# Rockwell service letter No. SL-AG-64

Service Letter No. SL-AG-64  
March 9, 1971

### ELEVATOR TRIM TAB MECHANISM

**EFFECTIVITY:** Aero Commander Model S-2R Thrush, Serial No. 1416R thru 1580R

VIEW LOOKING DOWN  
(L.H. SHOWN - R.H. OPPOSITE)

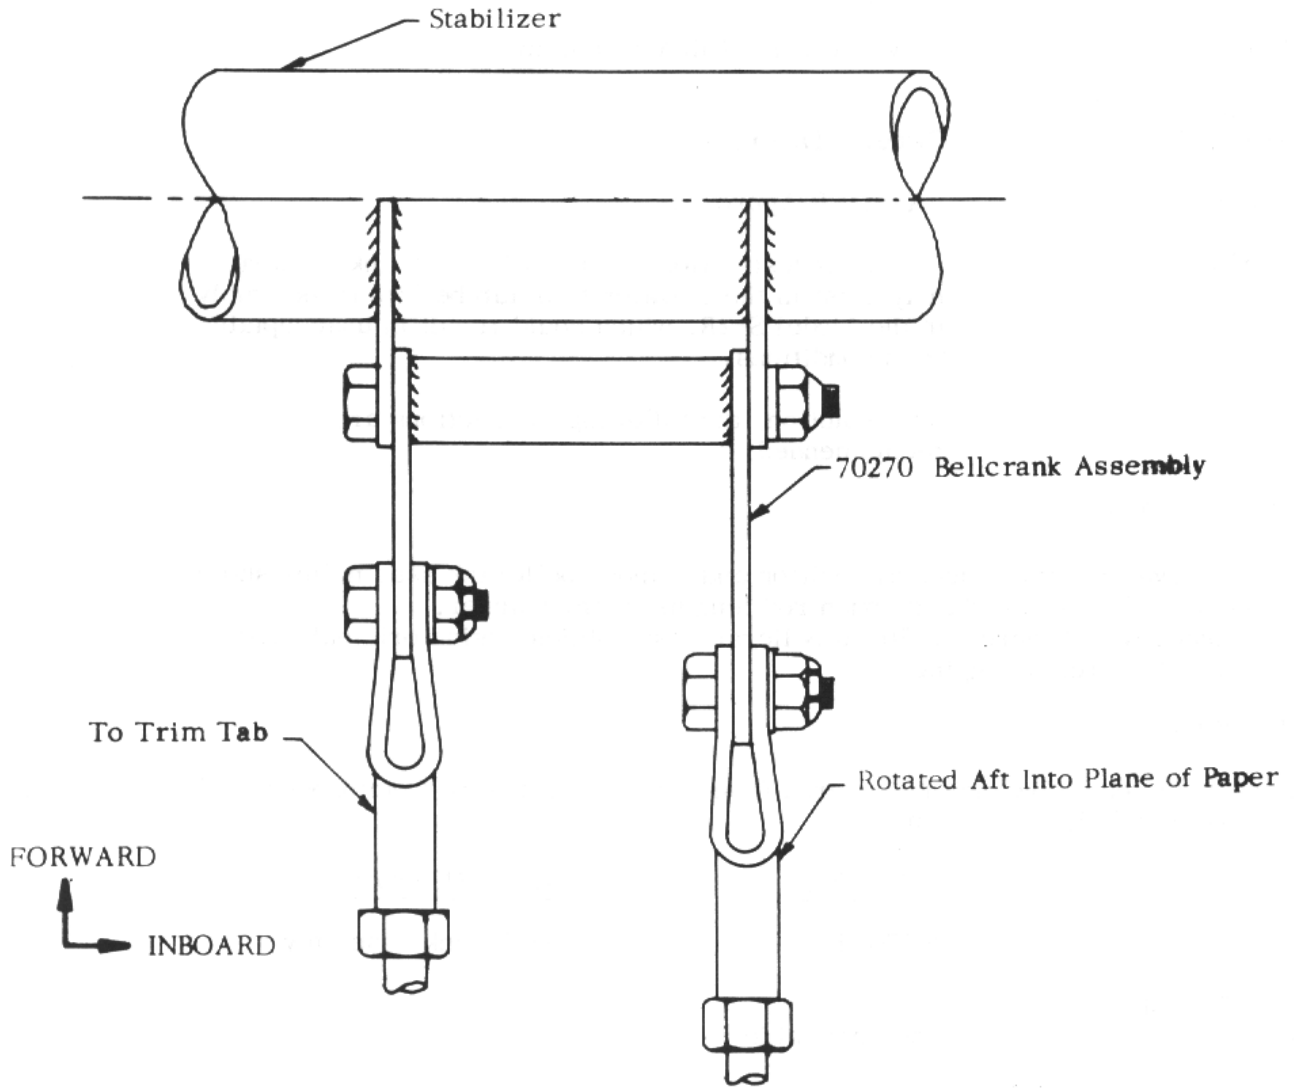
**REASON FOR PUBLICATION:** Service investigation has revealed that linkage wear may exist in the elevator trim tab bellcrank assembly in the Model S-2R, which could result in unacceptable trim conditions.

1. Set elevator trim in neutral position and remove bellcrank assemblies shown on Sheet 2. Do not change push rod lengths in any manner.
2. Replace with (improved) 70270 bellcrank assemblies, using original hardware.
3. Check for proper rigging.

<u>QTY</u>	<u>PART NO.</u>	<u>DESCRIPTION</u>
2	70270-1	Bellcrank assembly
